# HISTORIC AND DESIGN REVIEW COMMISSION

**HDRC CASE NO:** 2020-284  
**ADDRESS:** 724 N PINE ST  
**LEGAL DESCRIPTION:** NCB 1659 BLK G LOT 3  
**ZONING:** R-6, H  
**CITY COUNCIL DIST.:** 2  
**DISTRICT:** Dignowity Hill Historic District  
**APPLICANT:** Sunnie Diaz/SOFLIN DAVID & DIAZ SUNNIE R  
**OWNER:** Sunnie Diaz/SOFLIN DAVID & DIAZ SUNNIE R  
**TYPE OF WORK:** Demolition of a rear accessory structure new construction of rear accessory structure  
**APPLICATION RECEIVED:** May 21, 2020  
**60-DAY REVIEW:** Not applicable due to City Council Emergency Orders  
**CASE MANAGER:** Edward Hall  
**REQUEST:**

The applicant is requesting a Certificate of Appropriateness for approval to demolish the rear accessory structure at 724 N Pine.

The applicant is requesting conceptual approval to construct a rear accessory structure to replace the existing accessory structure that is proposed to be demolished.

# A100

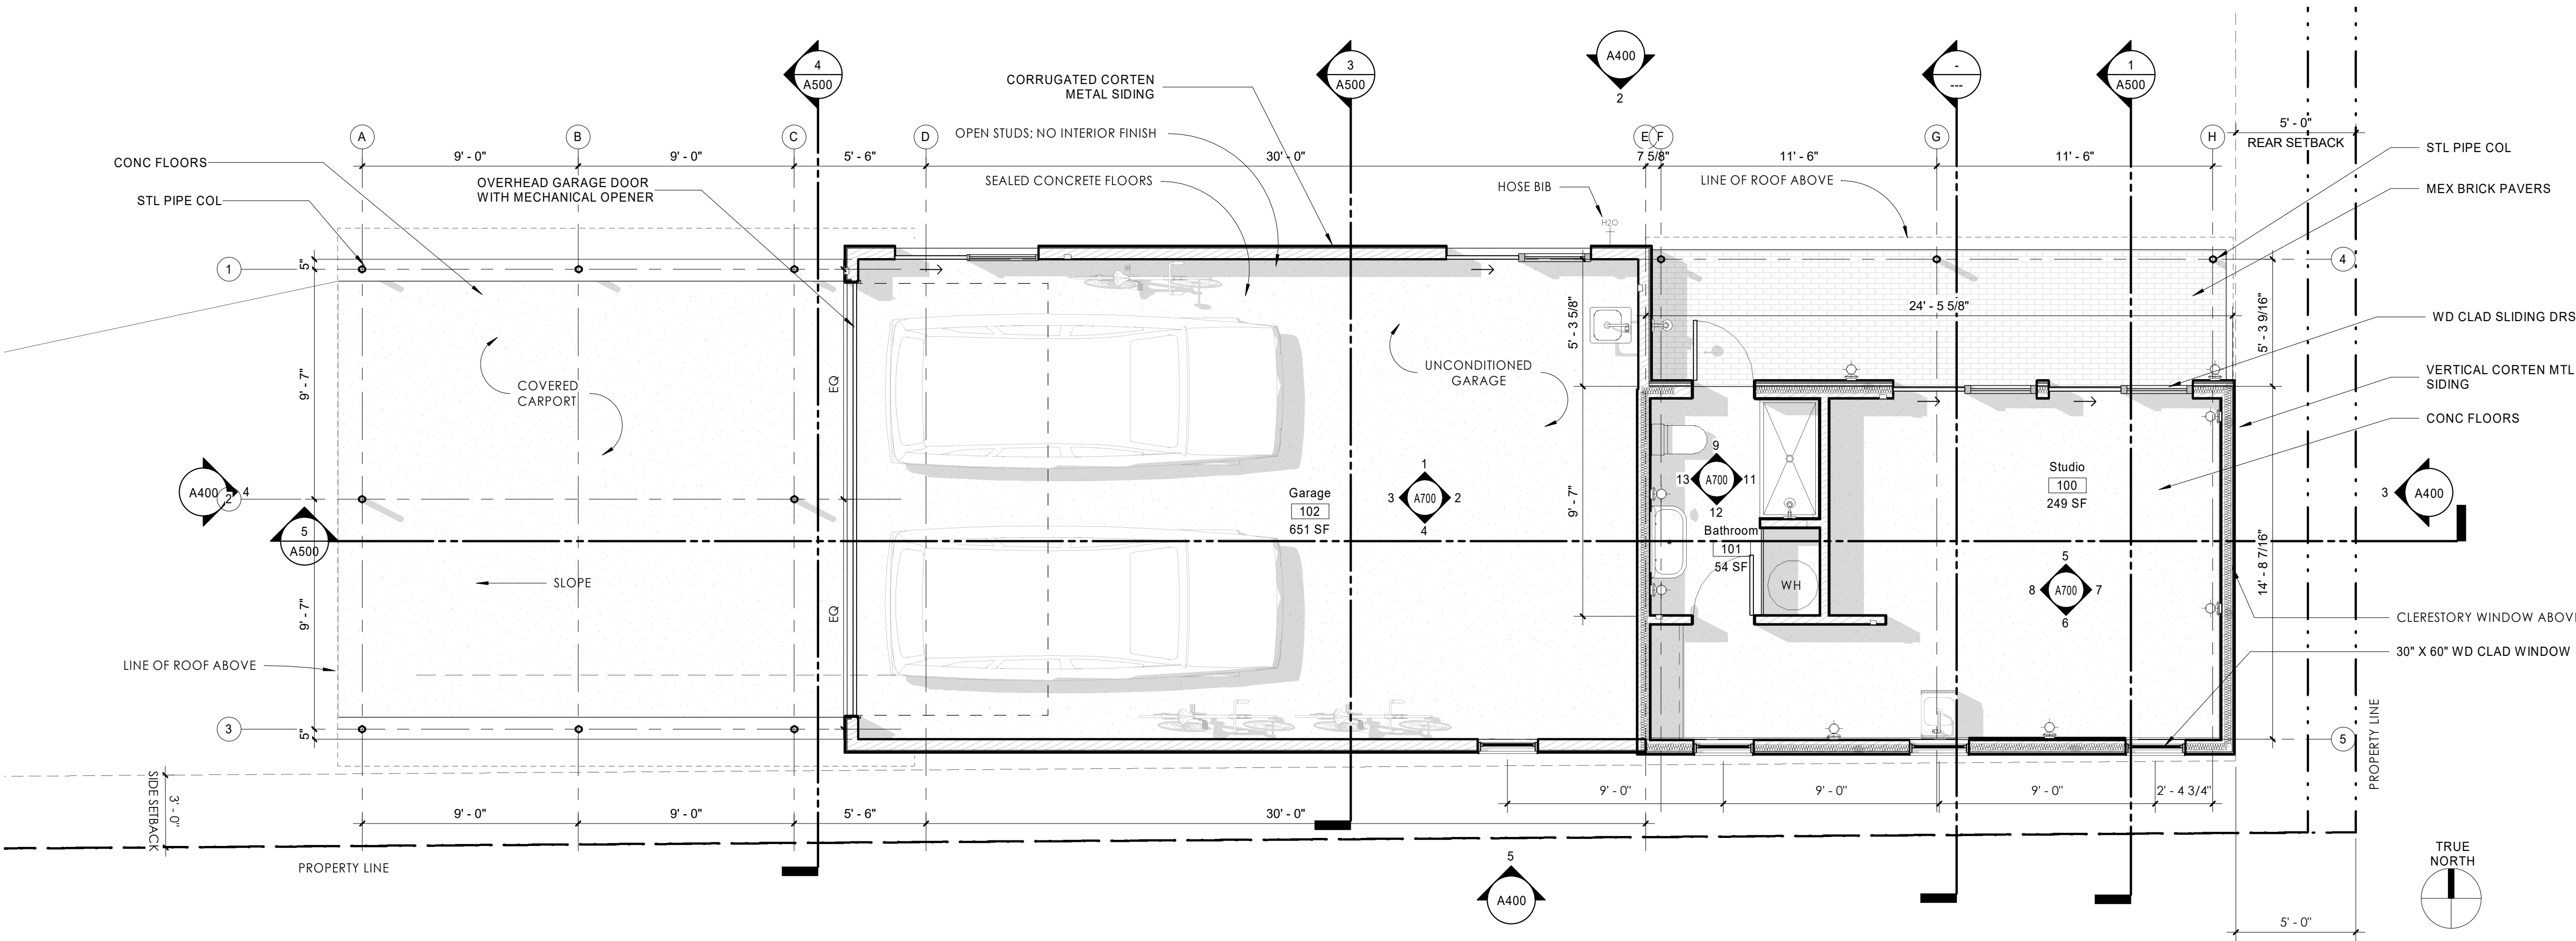
- h. MASSING & FORM – The Guidelines for New Construction 5.A. notes that rear accessory structures are to feature a massing and form that is visually subordinate that that of the primary historic structure in regards to their height, massing and form, should be no larger in plan than forty (40) percent of the primary historic structure's footprint and should relate to the period of construction of the primary historic structure. The applicant is proposing an overall footprint for the proposed new construction of approximately 1,000 square feet, not including the proposed covered carport. While the proposed footprint is larger than forty (40) percent of the historic structure's footprint, staff finds the proposed footprint to be appropriate given the overall size of the lot.

- j. **ORIENTATION & SETBACKS** – The Guidelines for New Construction 5.B. notes that the predominant garage orientation and historic setback patterns of the block should be followed. Generally, staff finds the proposed location, orientation and setbacks associated with the proposed accessory structure to be appropriate and consistent with both the Guidelines and existing structure's location.

Staff recommends conceptual approval of the proposed massing and footprint of the proposed accessory structure based on findings f through k. Staff recommends that the applicant utilize building materials found historically within the district in the development of the proposed new construction, and that materials that are not deteriorated beyond use be salvaged from the existing structure and incorporated into the proposed new construction.

EXTERIOR  
ELEVATIONS

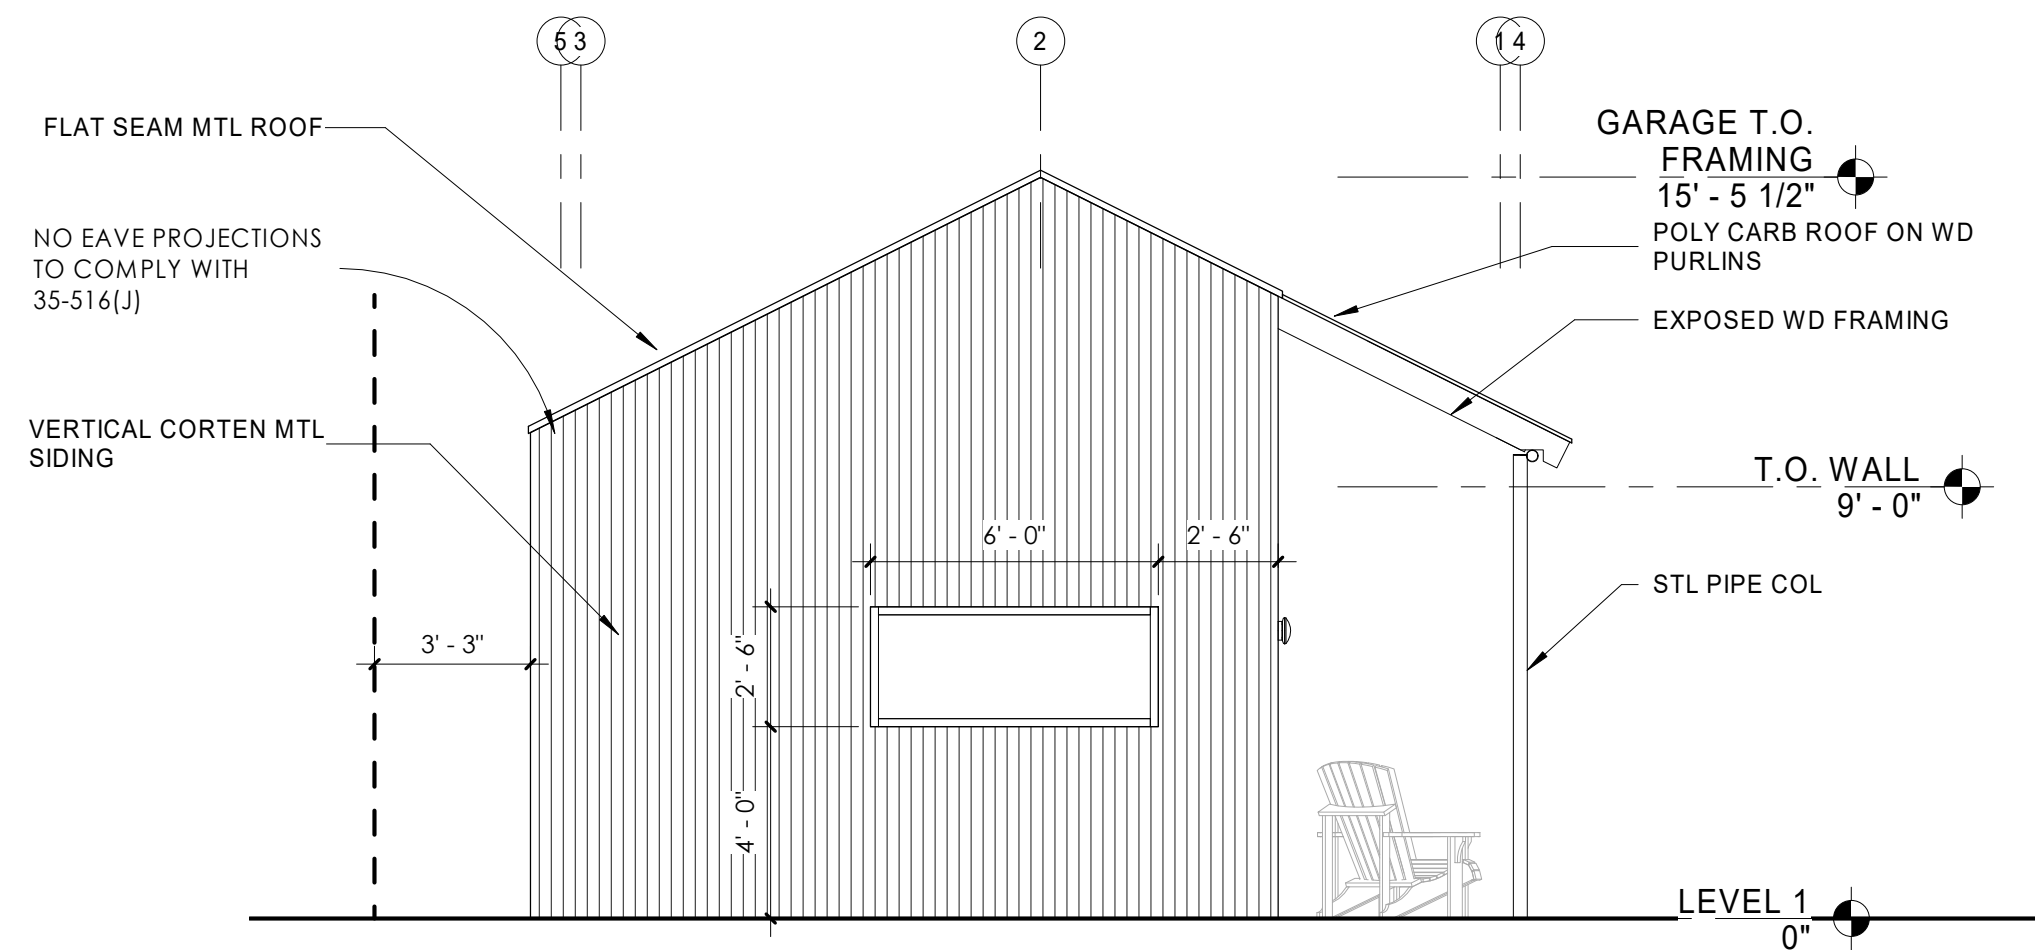
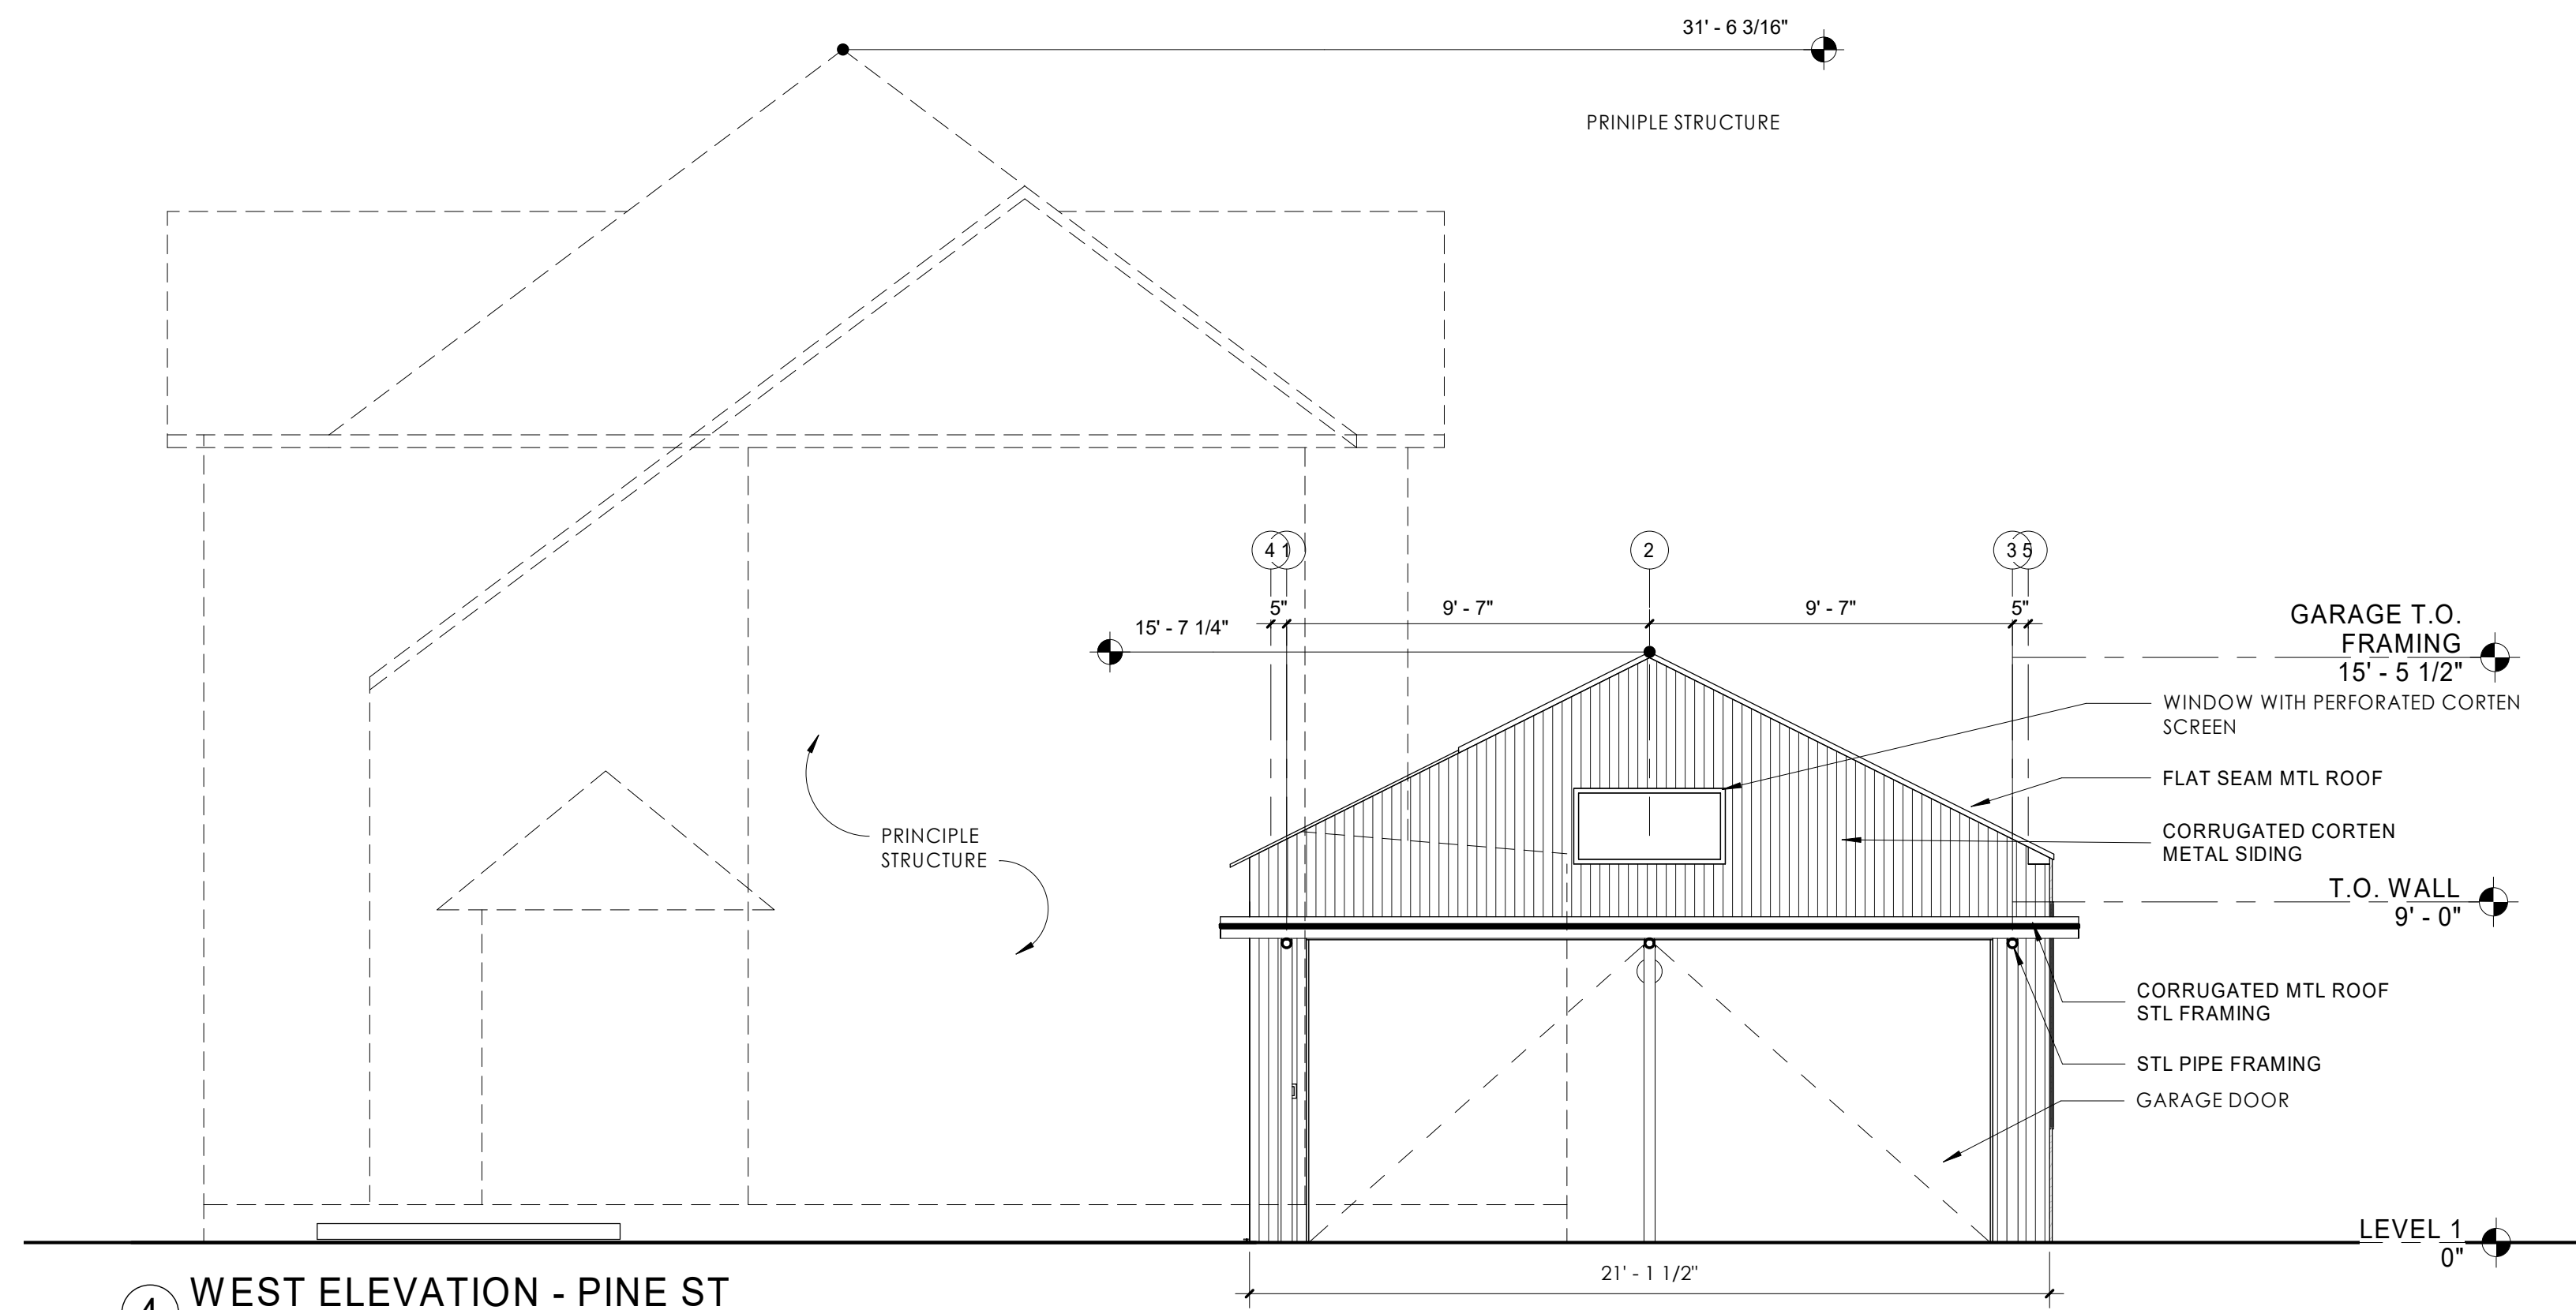
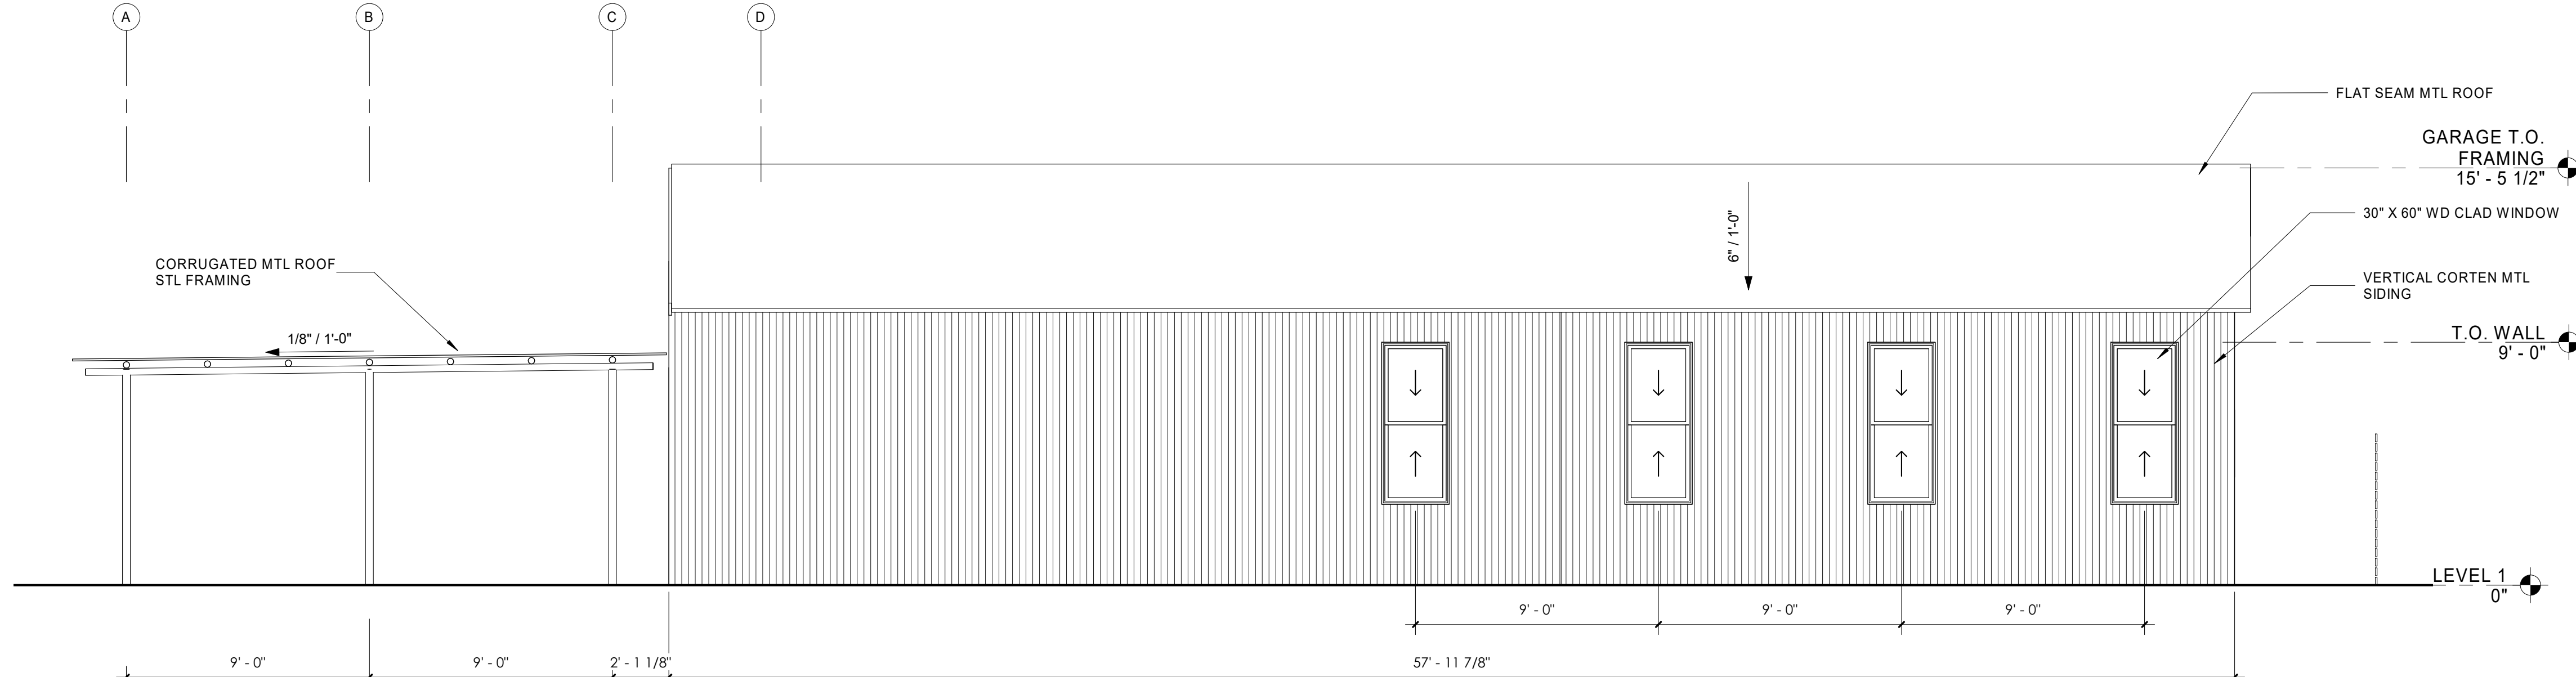
- i. **MASSING & FORM** – Regarding the overall height, the applicant has proposed to construct a one story accessory structure to feature an overall height of approximately sixteen (16) feet. Staff finds the proposed height to be appropriate.
